TOWN OF HUDSON

PUBLIC MEETING – MAY 18, 2022

RE: Town of Hudson Planning Board Review
Barclay Medical Office Site Plan, 2 Stonemill Drive
Tax Map 246, Lot 1; Acct. #1350-994
Fuss & O'Neill Reference No. 20030249.2160

Re: Town of Hudson Planning Board Review
Barclay Medical Office Site Plan, 2 Stonemill Drive
Tax Map 246 Lot 1; Acct. #1350-994
Reference No. 20030249.2160

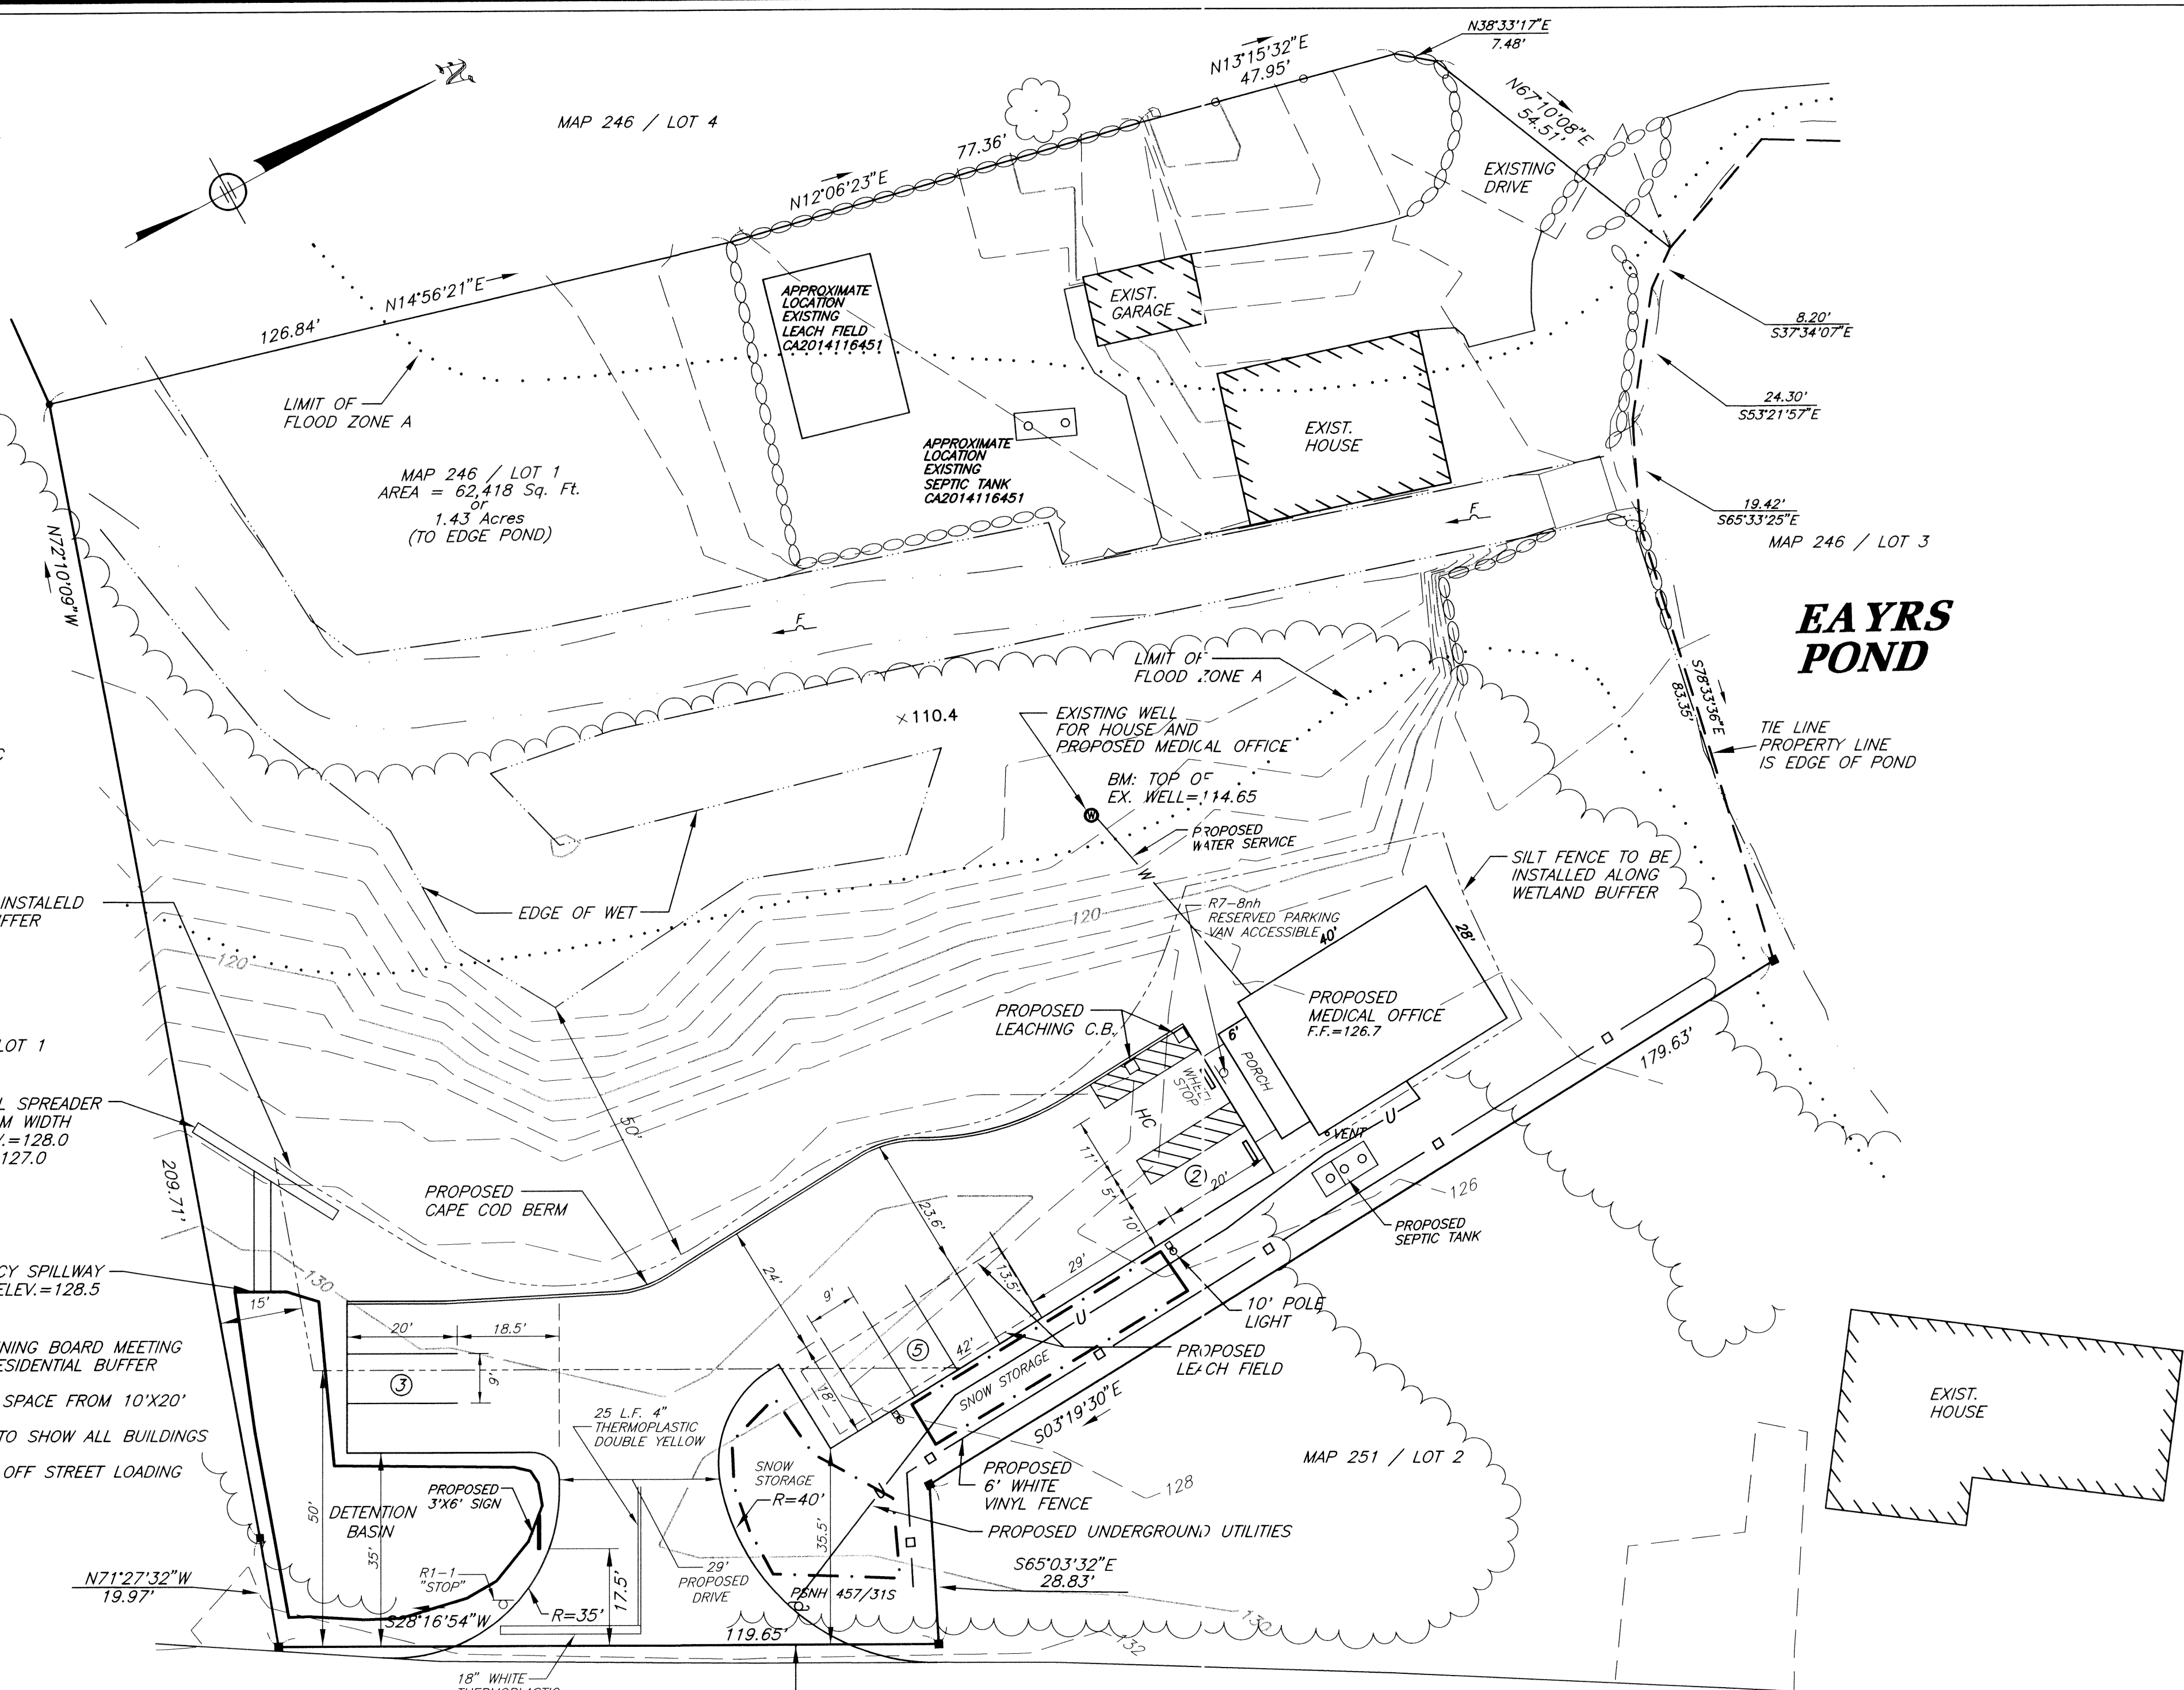
Current Fuss & O'Neill Comment: The applicant as revised the plan to now include 11 parking spaces. We note that this exceeds the number of spaces (10) stipulated by the Zoning Board of Adjustment for the site.

Current Fuss & O'Neill Comment: The applicant has revised the plan to make the aisle width more consistently 24 feet. We note that a vehicle in the handicap parking space and the perpendicular space right behind it may have trouble due to the limited maneuvering room and awkward layout. The handicap driver would have to back out and then turn 180 degrees to get out of the lot in a relatively small space or back up all the way past the

Current Fuss & O'Neill Comment: The applicant has relocated the handicap parking space on the plan set and added a sign location. We continue to recommend that details for the sign and striping be provided on the plan. The applicant should review the need for the handicap space to be considered van accessible to meet the ADA requirements.

Current Fuss & O'Neill Comment: The applicant has noted on the Grading Plan that the walk and porch are to slope up to the building and that no step is proposed. The applicant has also provided a spot grade for the handicap parking space and walkway. The area labelled 'porch' does not have any spot grades shown so we are unable to verify if the proposed grading meets ADA requirements. Also, we note that what appears to be a step is still shown on the Site Plan.

- j. **New Fuss & O'Neill Comment:** With the walk area grading being noted as flat and with no curbs at the parking lot, the applicant should review the need for wheel stops on the adjacent parking spaces.

Current Fuss & O'Neill Comment: The applicant has stated that approved waivers will be noted on the site plan. We note that none were noted on the plan set received for review and the applicant has not provided legible waivers to replace those that we were unable to discern in the last review.

Current Fuss & O'Neill Comment: The applicant has noted that the State approved the driveway permit. The applicant should review the need for a waiver from showing the sight distance on the plan set as this is required by the Town Regulation.

Current Fuss & O'Neill Comment: The applicant has noted in their response letter that this comment is 'Not Correct'. We continue to note that those details are not provided in the plans.

Current Fuss & O'Neill Comment: The applicant has noted this comment as being irrelevant. When used in conjunction with a stop sign, a stop bar should be located in line with that stop sign unless there is the potential to obscure sight distance. Sight distance lines were not provided by the applicant for the proposed driveway.

Current Fuss & O'Neill Comment: The applicant has revised the plan and noted that the existing well will now be used to service the existing home and the proposed medical office. No information was provided about the existing well to verify that it's capacity and condition will be adequate for both uses.

Current Fuss & O'Neill Comment: A spot grade has been added near one of the catch basins. The applicant should confirm that this elevation is proposed to be the same rim elevation at both catch basins.

Current Fuss & O'Neill Comment: The applicant has noted that this comment is irrelevant in their response letter. The applicant has added note #23 to plan sheet #1 which states that approximate tree clearing limits will be the building set back line. We note however that the parking lot is partially outside of this area as are the fence, lighting, and other site elements. We recommend that the applicant show the actual limits of clearing on the plan set.

1. c, e, g and h – items resolved
2. a, e – items resolved
3. a, c, d, e - NHDOT permit issued/approved. Not planning board jurisdiction
5. b, c, d – Septic plan and wells, NHDES approved.
6. e,g – there are no improvements in the wetlands buffer
h thru p – items resolved.
7. irrelevant
8. item resolved
- 9 b. – irrelevant
c. – lighting levels not great enough. All lights will be hooded and down as already noted on
plan.
- 11 c.- incorrect

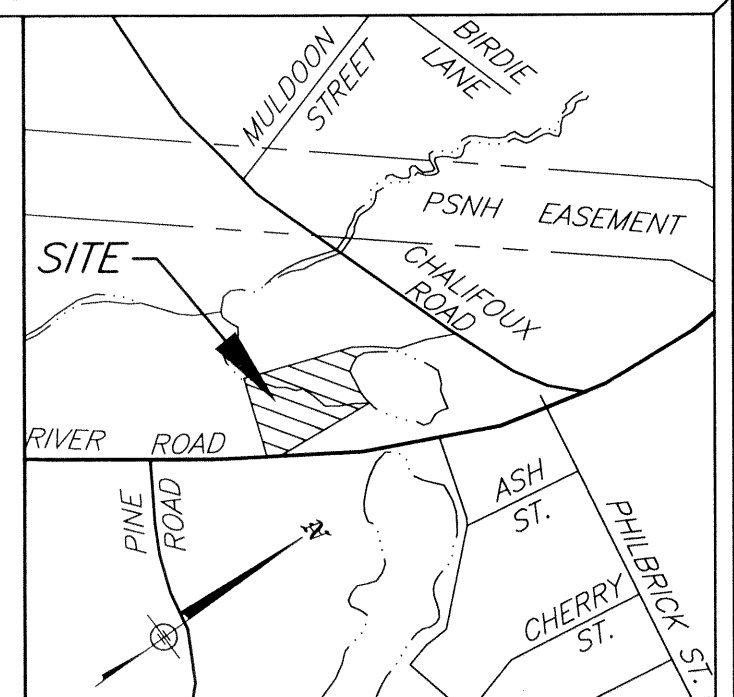
1. Sheet 2 (Existing Conditions) is showing a well location labeled “Proposed well for medical office”. Staff believes it is an error and should be removed.
2. The abutter information on the upper left corner for Map 246 Lot 2 is correct. However, the lot label (on the plan) for Map 246 Lot 2 is mislabeled as Map 251 Lot 2.
3. The Applicant previously withdrew a waiver request for reduced parking width aisle since their April 11, 2022 plan set appeared to provide the requisite width. However in the most recent plan set the width has been reduced to avoid wetland buffer impacts. Further, while the April 11th set showed a 24-foot aisle width for almost all spaces, the northern most space of the grouping of 5 spaces does not have a 24-foot aisle. A waiver from §275-8.C.(5)(a) would be required for the current plan set to be approved.
